**MEMORANDUM**

**SUBJECT:** BZA Case 20568: 1801 Maryland Ave NE - to permit extension of zone boundary line from the portion of the less restrictive use zone (MU-7) by thirty-five feet into the RA-2 zone, to construct a residential apartment building.

Exhibit 39A Sheet SD1.4

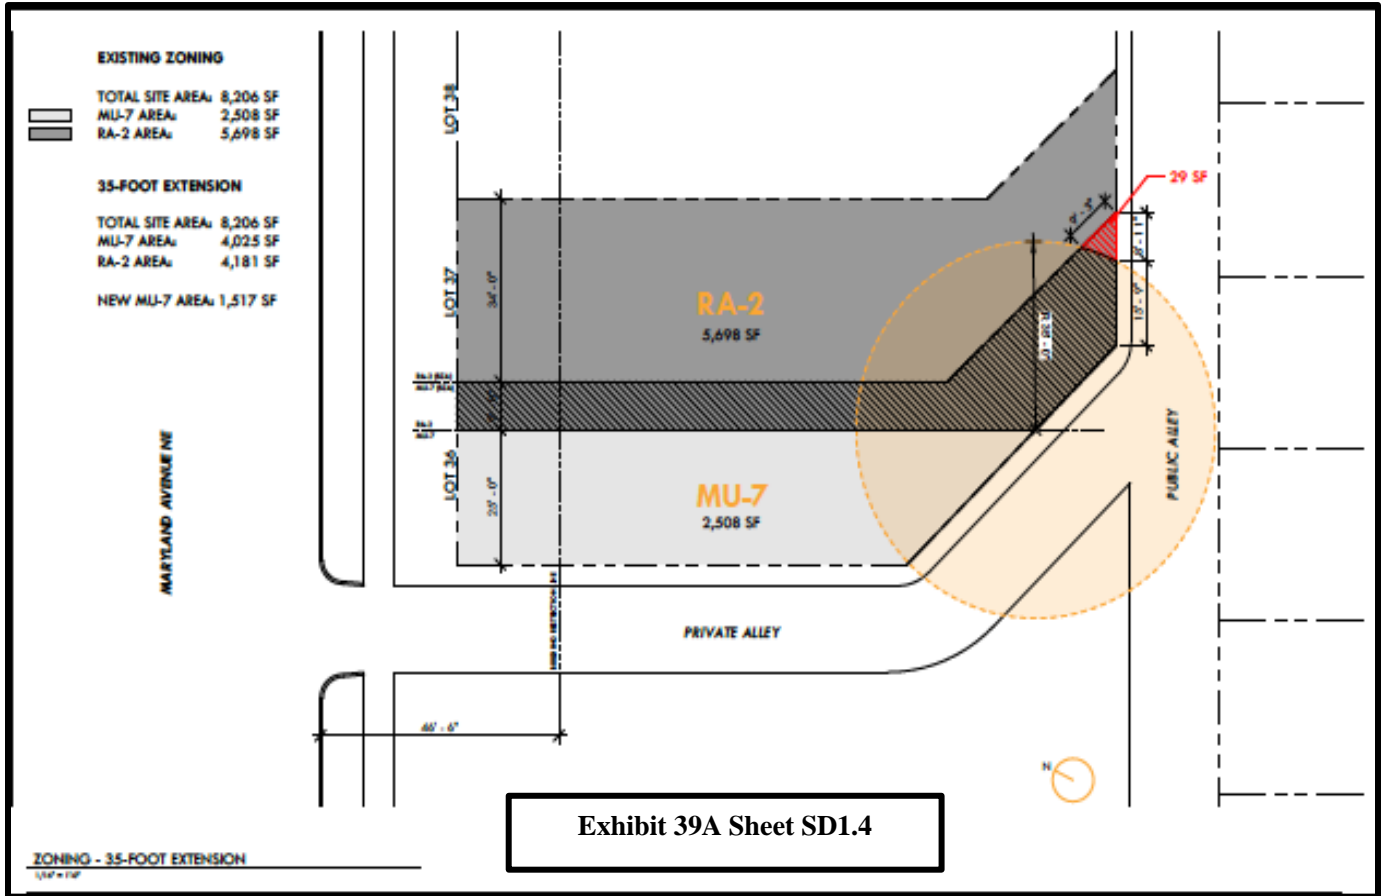
As shown in the sheet referenced above (Exhibit 39A, Sheet SD1.4) the extension request is for a 35 feet extension from the MU-7 zone within the split-zone Lot 36 into the RA-2 portion of the lot, for an area of 1,517 square feet.
